Document Number:	N14213
Date:	2010-01-28
Replaces:	
Document Type:	Disposition of Comments
Document Title:	Disposition of Comments for ISO/IEC 16512-2/FPDAM 2, RMCP-2: Messages and code values
Document Source:	SC 6/WG 7 Barcelona meeting
Project Number:	
Document Status:	As per the SC 6 Barcelona resolution 6.7.5, this document is circulated for information.
Action ID:	FYI
Due Date:	
No. of Pages:	26
ISO/IEC JTC1/SC6 Secretariat Ms. Jooran Lee, KSA (on behalf of KATS) Korea Technology Center #701-7 Yeoksam-dong, Gangnam-gu, Seoul, 135-513, Republic of Korea ; Telephone: +82 2 6009 4808 ; Facsimile: +82 2 6009 4819 ; Email : jooran@kisi.or.kr

Title: DoC for comments in FPDAM ballot of Draft Amendment 2 to ISO/IEC 16512-2:2008(X.603.1)

Source: SC 6/WG 7 Meeting (Barcelona, January 2010)

Status: This document is a DoC on Korea and UK comments in N14164, Summary of Voting on 6N14056, Text for FPDAM ballot, Draft Amendment 2 to ISO/IEC 16512-2:2008(X.603.1) which was discussed in January 2010 Barcelona ISO/IEC JTC 1/SC 6/WG 7 Meeting.

Figure 44 – DATAPROFILE control

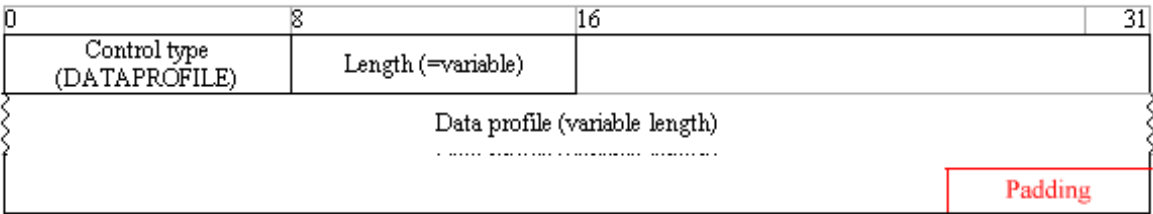
GB 10	7.3.1	DATA- PROFILE Figures 44, and 45	te	<p><u>DATAPROFILE control</u></p> <p><u>Length field</u>. We disagree with the logic of the text relating to the length of the control. 'n' is not defined and it is the length of the control, and not the data field, that is required to be a multiple of 4-bytes.</p> <p>The maximum value that can be expressed in a 8-bit field is 255, and this implies that the maximum length of the control that is divisible by four is 252 (0xFC). The maximum length of the data profile field is 250 (0xFA).</p> <p>The text of the length field is too long and too complicated. It is sufficient to define a maximum length of the field without providing justification.</p> <p><u>Dataprofile figures 44 and 45</u>. We consider that one figure is sufficient to define the DATAPROFILE control and that a padding field should be added to figure 44.</p>	Replacement text is added below:	Agreed. Replacement text accepted.

b) *Length* – denotes the length of the control. The value shall be set to n/8 in hexadecimal which means the total length of the DATAPROFILE control in byte. Since the length of this field is 8-bit, maximum value of this field is 0xFF which means the length of the DATAPROFILE control is 255-byte including 253- byte of the “Data profile” field. But, since the length of the Data profile field is aligned to multiple of 4-byte, maximum value of the Length field can be 0xFE.

The DATAPROFILE control format is shown in Figure 44. The description of each field is as follows:

- a) *Control type* – This field denotes the DATAPROFILE control. Its value shall be set to 0x03 (see Table 4).
- b) *Length* – This field shall be set to the length in bytes of the DATAPROFILE control. Its value shall be a multiple of four bytes (see item d in this list) and it shall not exceed 0xFC.
- c) *Data profile* – This field shall contain the data profile for the MA formatted in text mode. It follows an SML-like encoding scheme. An example is shown in Figure 84.
- d) *Padding* – If the total length of the control type, length and data profile fields is not a multiple of 4 bytes, the padding field shall be filled with zeros to ensure that the length of the DATAPROFILE control is a multiple of 4 bytes.

Figure 45 has been incorporated in Figure 44
